**Pre-Bid Clarification Questions – Solicitation 12441926Q0047
CAS Education Building Heat Pump Replacement (Ozark, AR)**

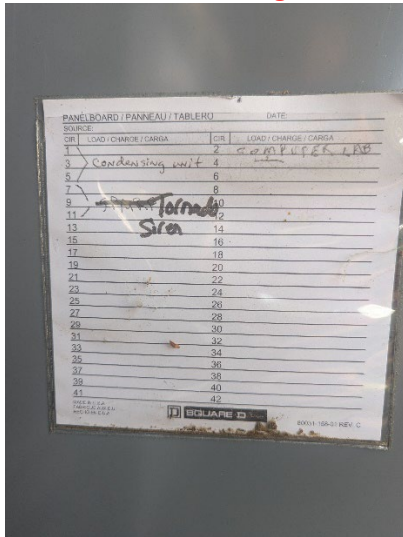
17. If existing raceways to the attic air handler and outdoor disconnect are found in good condition, will the Government allow their reuse?

No – Per the SOW Part 1, 1.1 Description A., 1. a Replacement Work Includes: 4) New Branch circuit wiring, conduit, and overcurrent protection devices, local equipment disconnects at both interior and exterior units.

CASS EDUCATION DIAGRAM NORTH

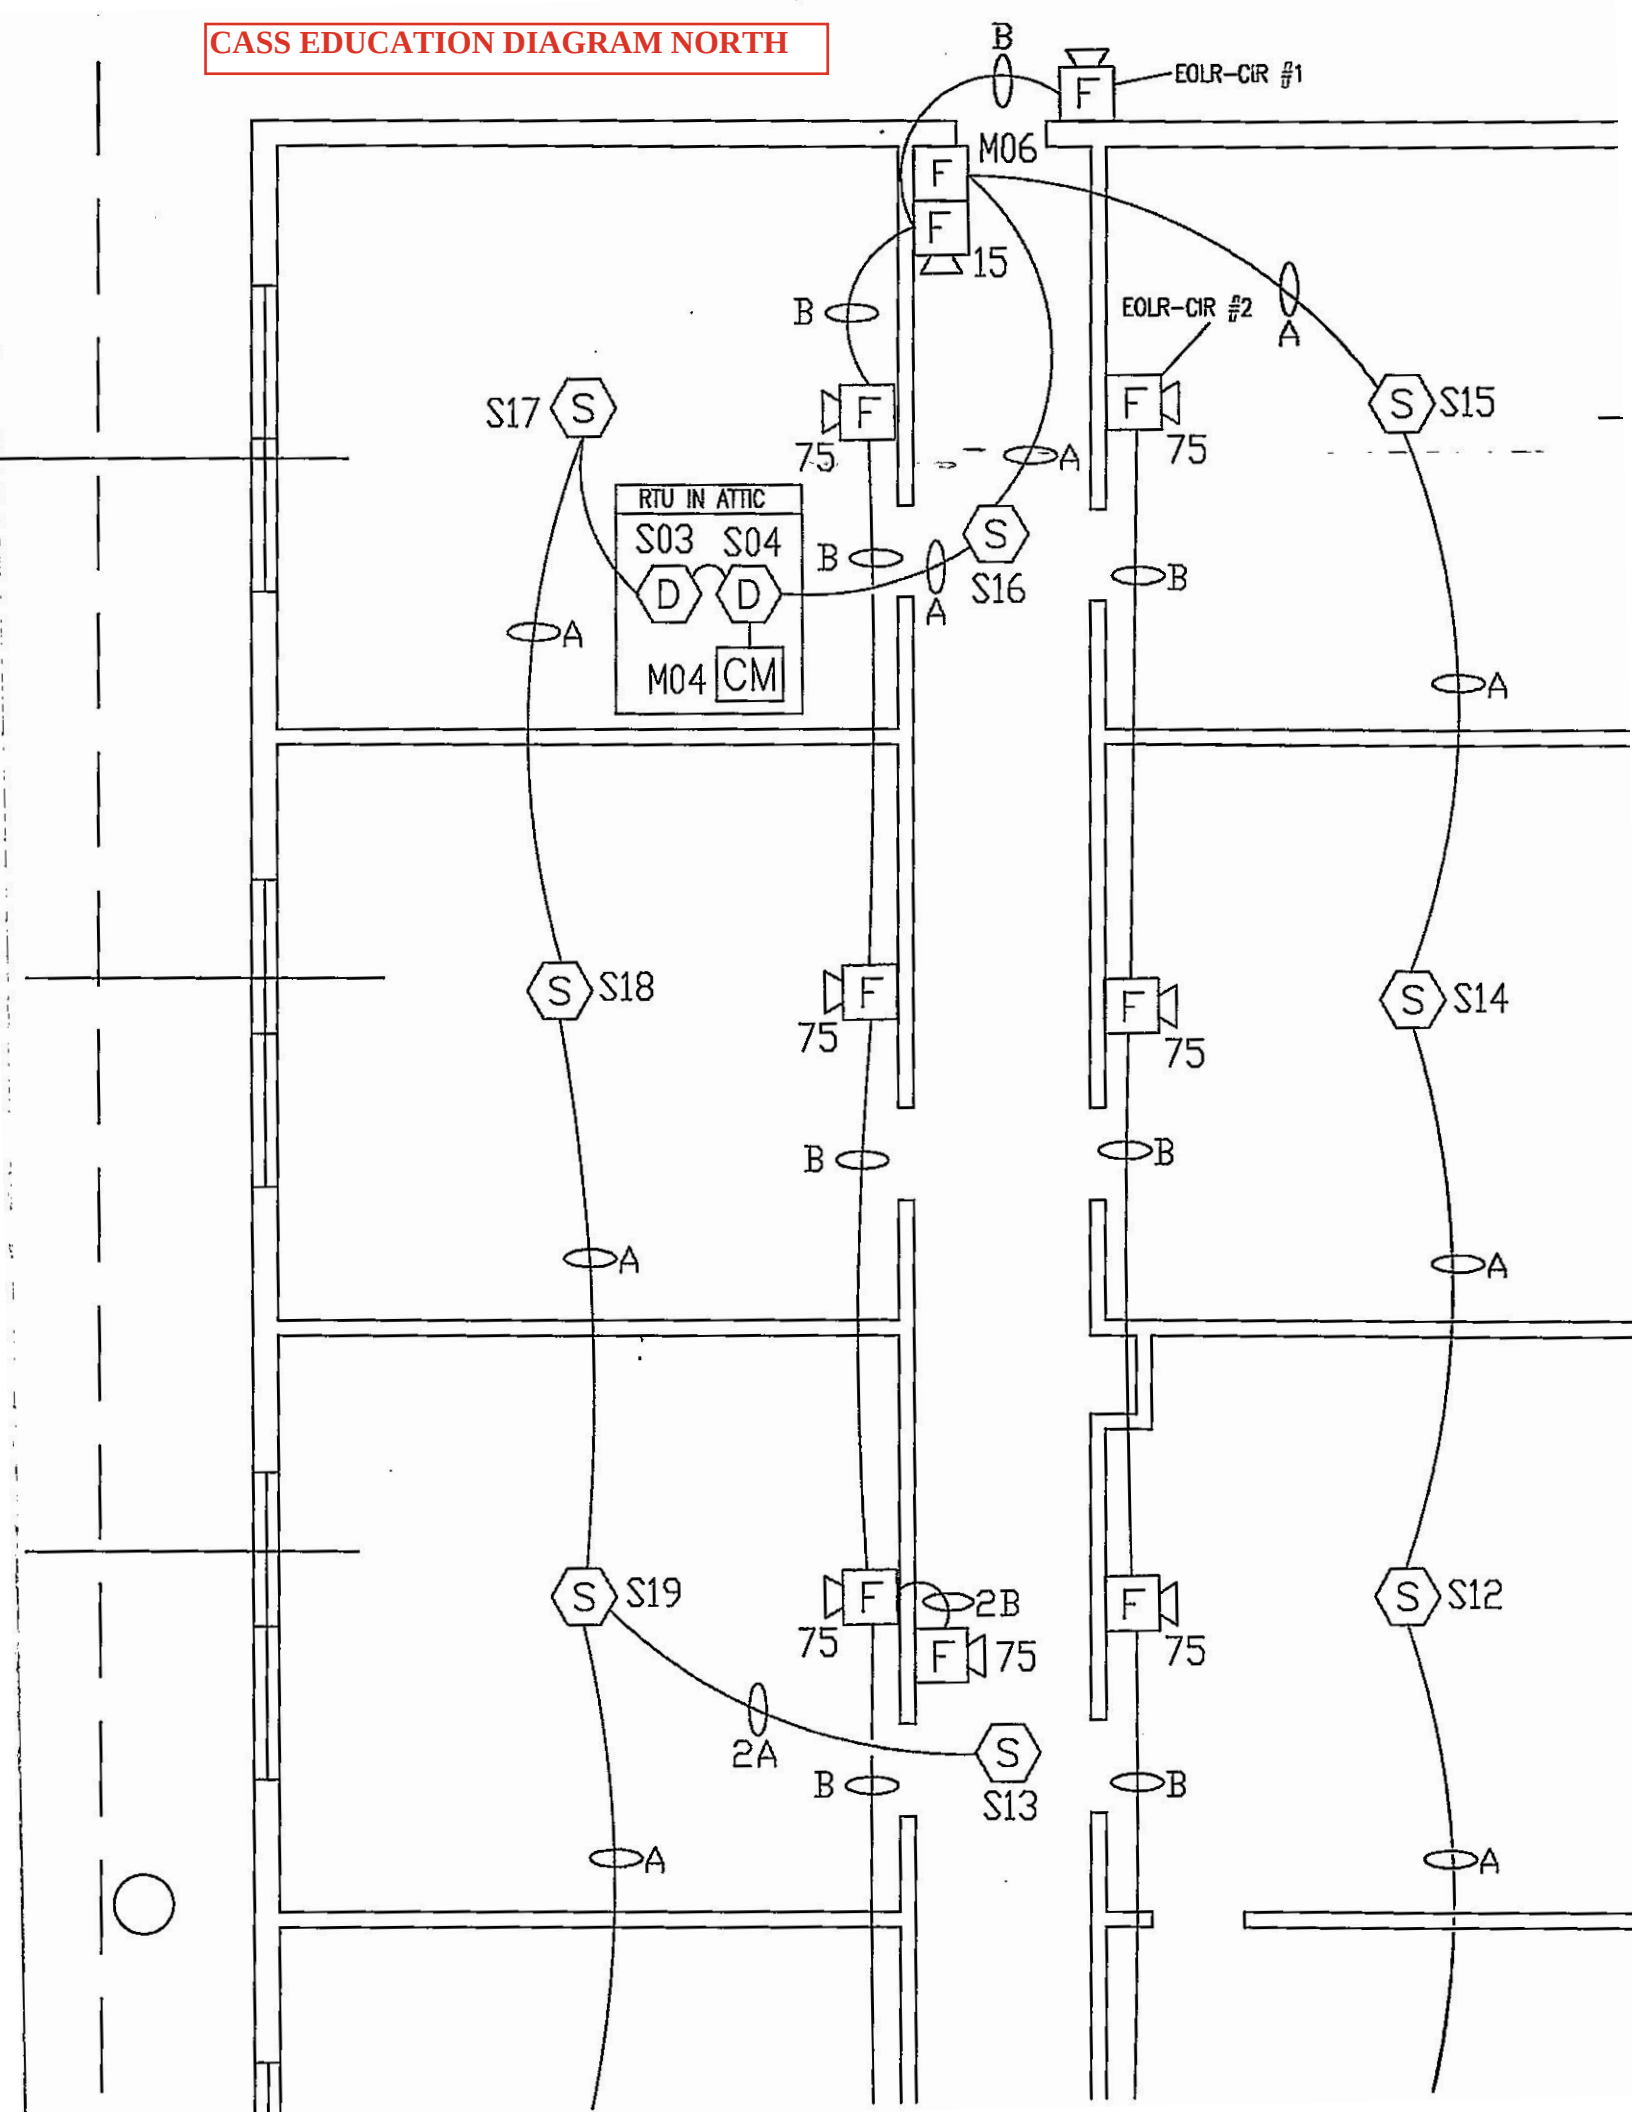
11. Will the Government provide existing fire alarm panel documentation or wiring diagrams to support duct smoke detector integration?

PDF scans Cass Ed Fire Diagram North and South (see below for both) are the only known diagrams and will be attached; Per SOW Part 11.7 FIELD VERIFICATION AND COORDINATION OF WORK A. Drawings are schematic or typical in nature or intended to identify location of work. The Contractor shall be responsible for field verification of existing conditions and coordination of new work with those existing conditions. Examples below are intended to demonstrate the intent of this statement but are not inclusive of all field verification and coordination. Notify COR when specified requirements conflict with field verification.
